**RE: Addendum No. 2
Canal Road Improvements from SR-161 to Wilson Blvd**

In response to questions and comments received by Thompson Engineering, Inc., and the City of Orange Beach, the plans, contract documents and specifications for the above referenced project are hereby revised as follows:

SHEET NO. : 2-H

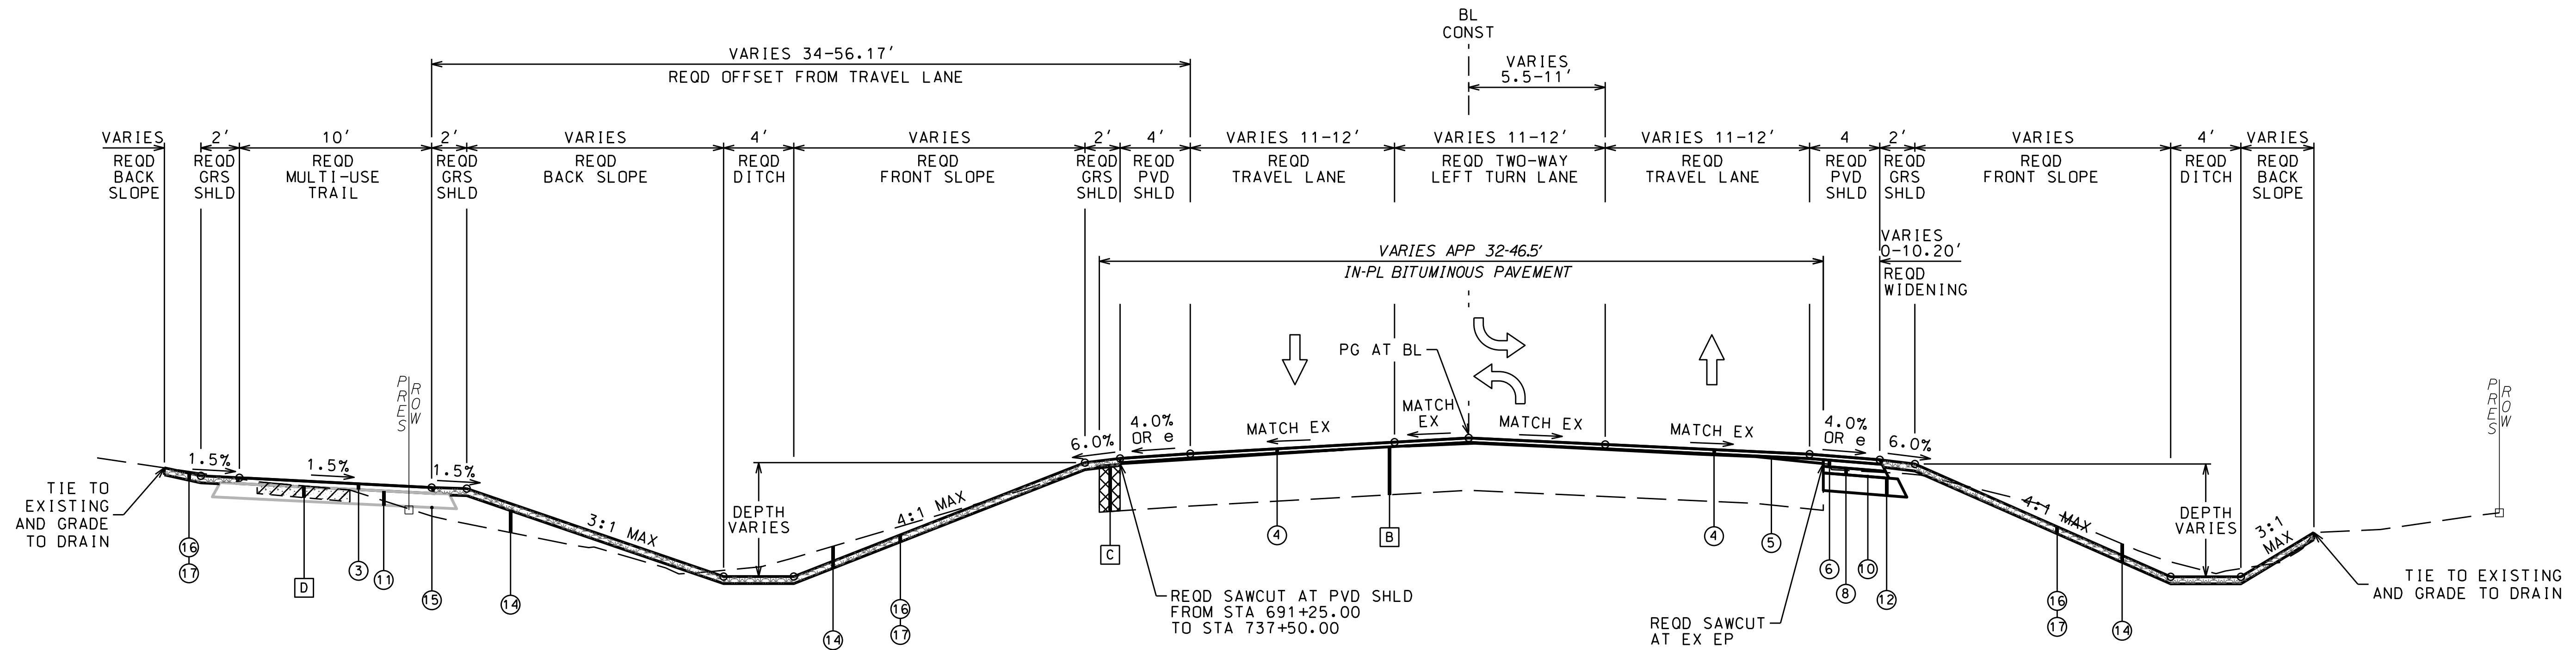
2. Plans
 - I. On Sheets 2-F through 2-J, revise the rate for 424A-340 in the Required Materials Legend from 165 lbs/sy to 220 lbs/sy
 - II. On Sheets 3 through 3-A, revise the quantities for pay items listed above

SHEET NO. : 2-K

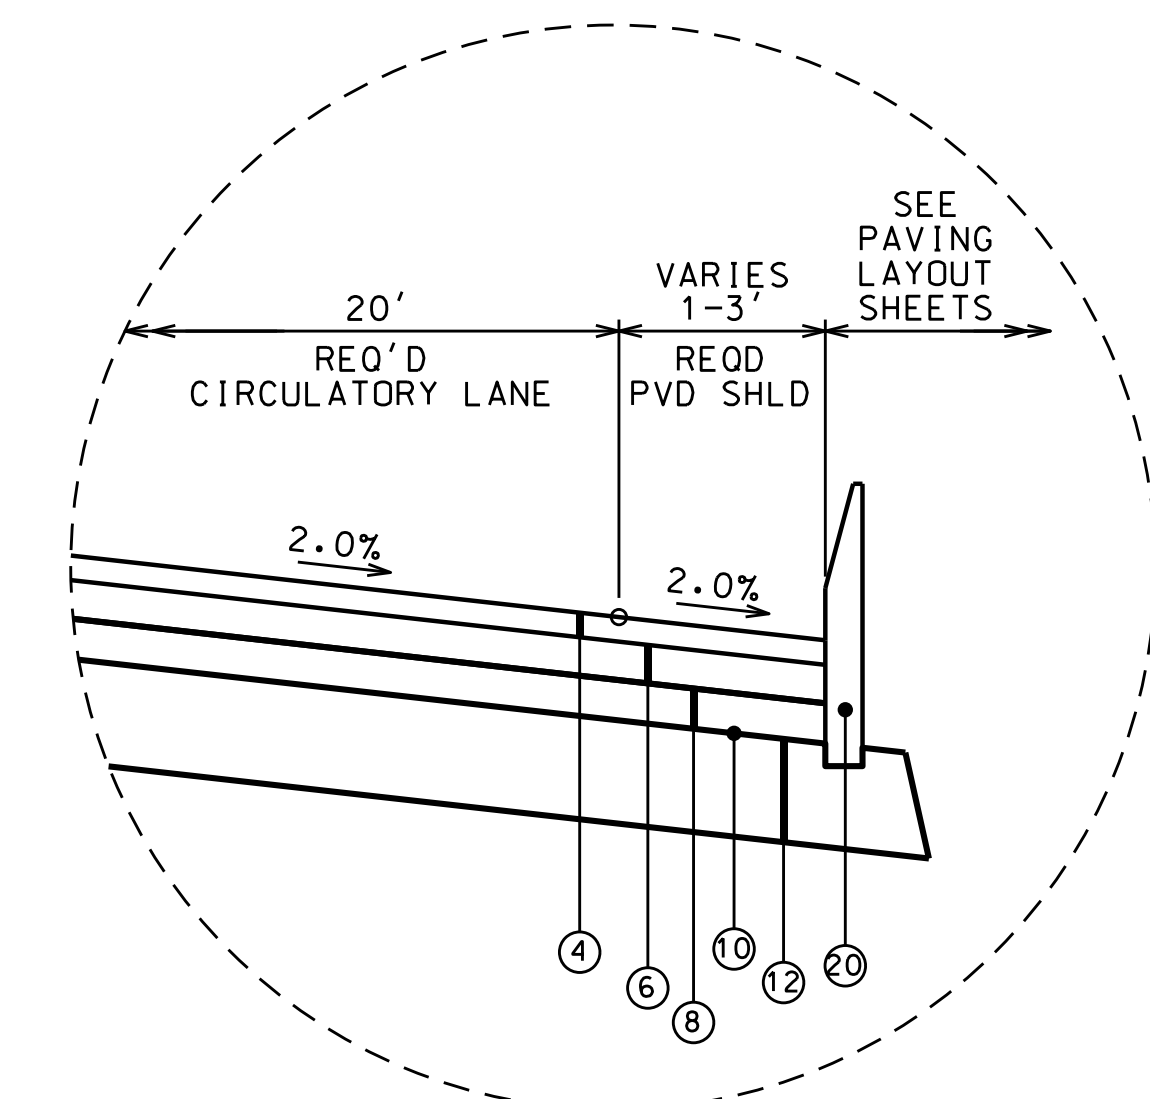
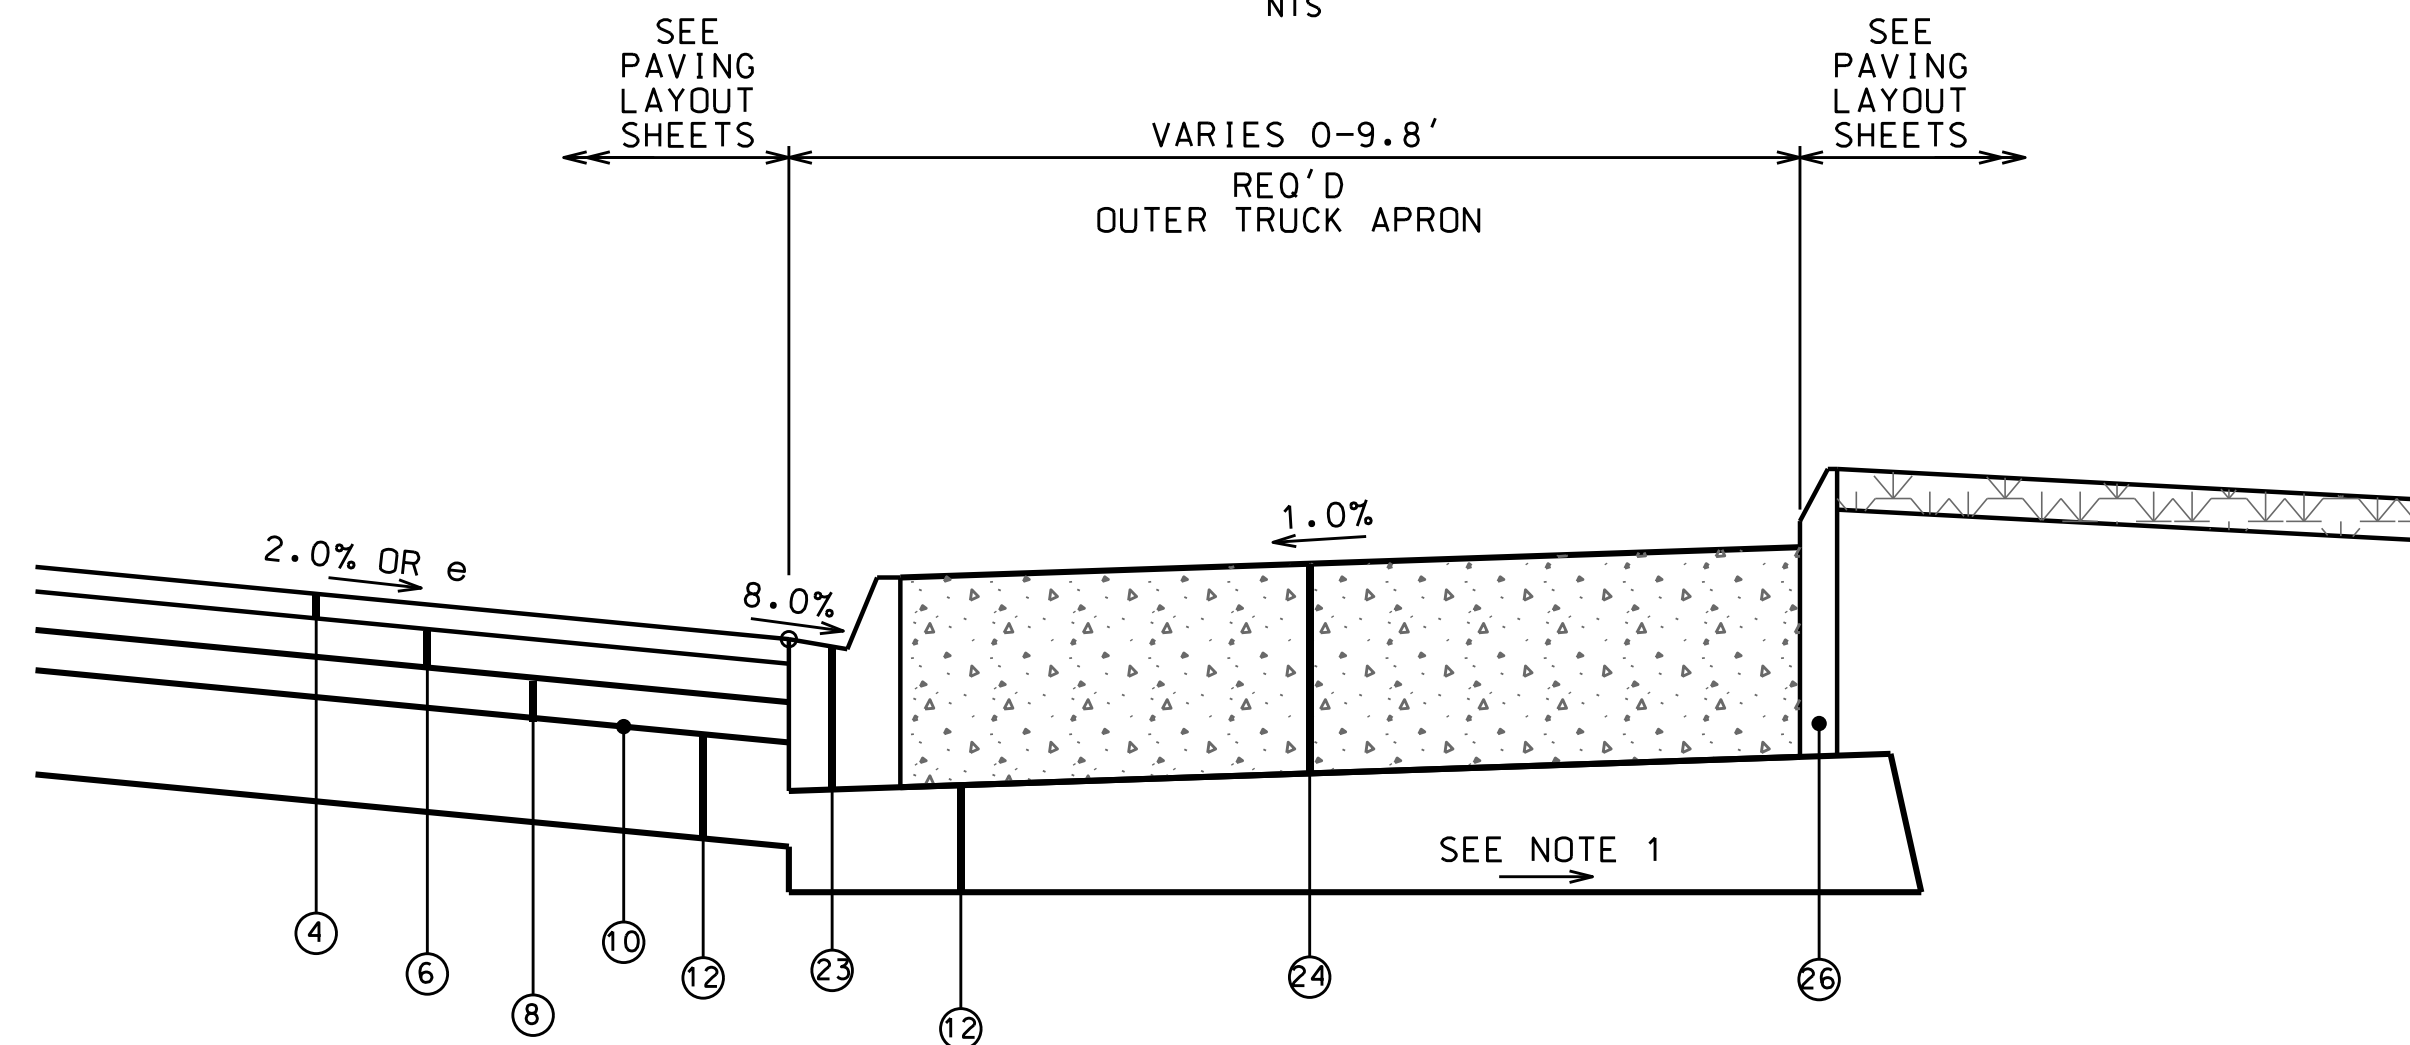
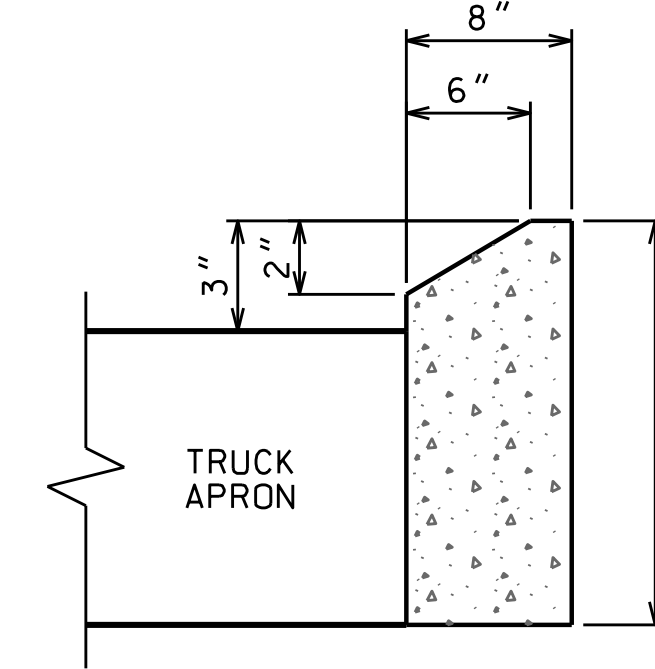
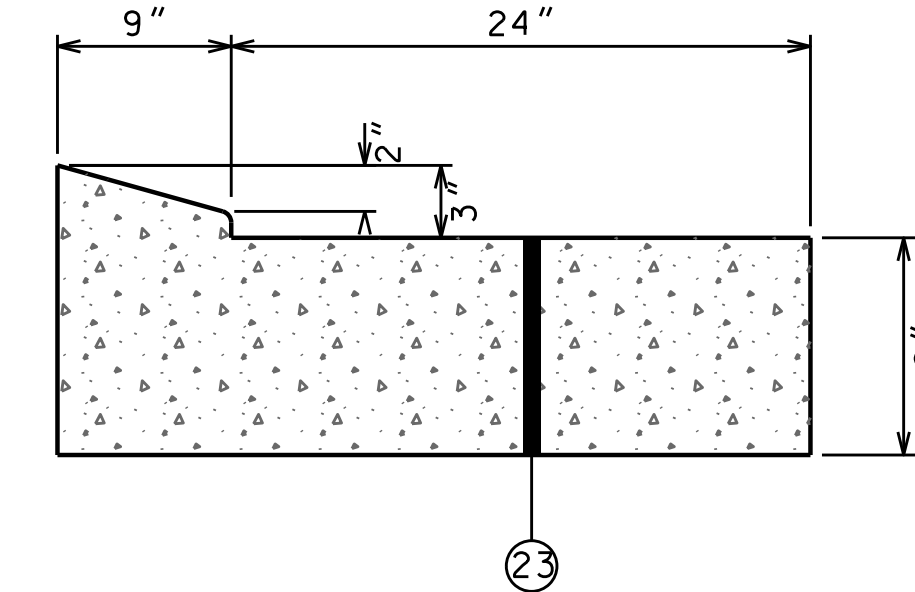
- VII. On Sheets 40 through 47, revise the signing plan as shown
 - VIII. Add the following sheets:
 - i. Sheets 2-K, 2-L, 2-M for additional typical sections
